DART AEROSPACE LTD	Work Order:	23295
Description: Tube Assembly	Part Number:	D3298-005
Dwg: D3298 Rev. A At A2 PAGE 3 REF 05.05.19	Qty:	10
		Page 1 of 1

DESIGN <i>T</i>	DRAWN BY <i>R</i>	DART AEROSPACE LTD HAWKESBURY, ONTARIO, CANADA	
CHECKED <i>H</i>	APPROVED <i>H</i>	DRAWING NO. D3298	REV. A SHEET 3 OF 7
DATE 04.07.06		TITLE TUBE ASSEMBLIES	SCALE NTS

From: "Jason Loader" <jloader@eaglecopters.com>
To: "Roberto Fuentes" <robertof@dartaero.com>
Sent: Wednesday, September 07, 2005 3:03 PM
Subject: RE: D3298-005 tube

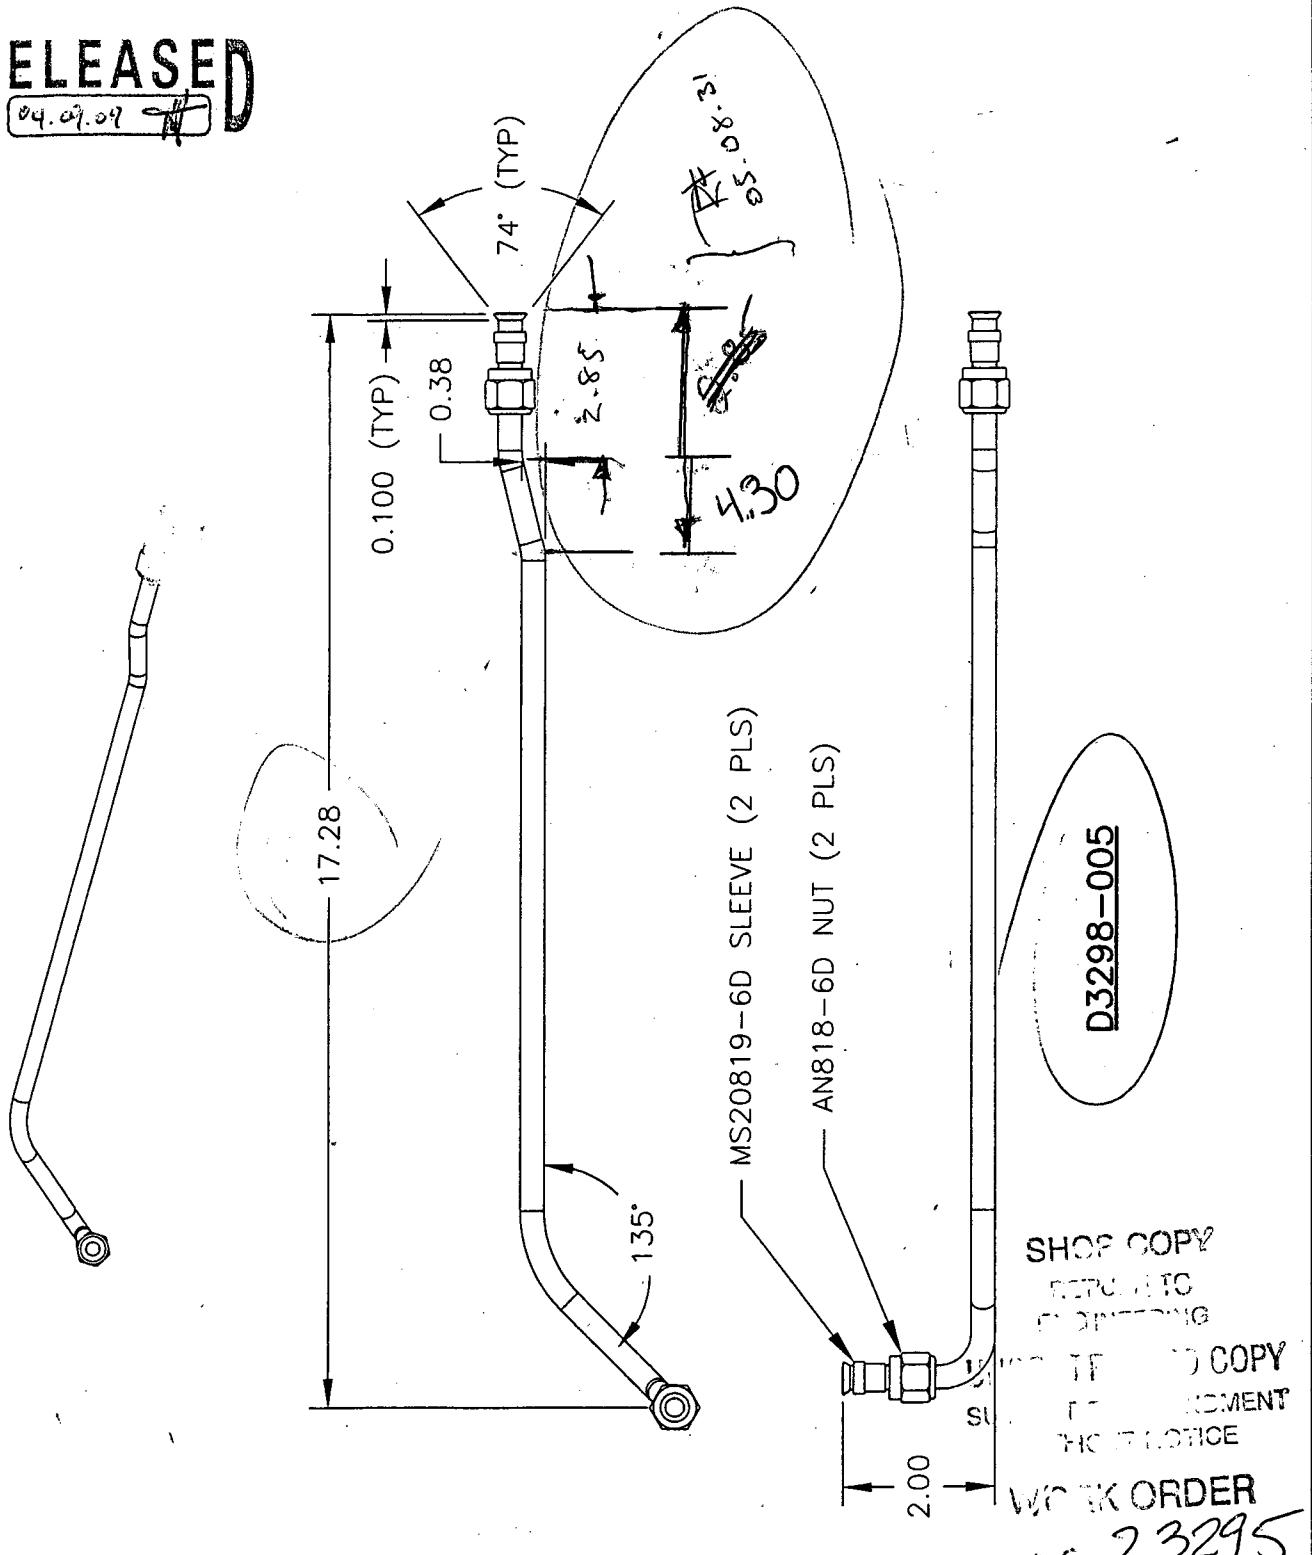
THE MEASURES WAS CHANGED
AFTER I'VE MADE THEM

NCR:		WORK ORDER NON-CONFORMANCE (NCR)						
DATE	STEP	Description of NC Section A	Corrective Action Section B			Verification Section C	Approval Design Mgr	Approval QC Inspector
			Initial Design Mgr	Action Description Design Mgr	Sign & Date			
05-09-08	4	Parts are a $\frac{1}{4}$ " too long & also the new template on the total length.	PP 05-09-08	Parts are acceptable as per attached sheet.		2 05-09-08	PP 05-09-08	2 05-09-08

Please can you respond this e-mail today, see the attach sheet.

There is enough flexibility in the existing lines under the engine deck that plus or minus 1/4" on this line will not cause a problem. There is always slight variations with the existing lines so slight changes to the bends of lines to improve fit is typical.
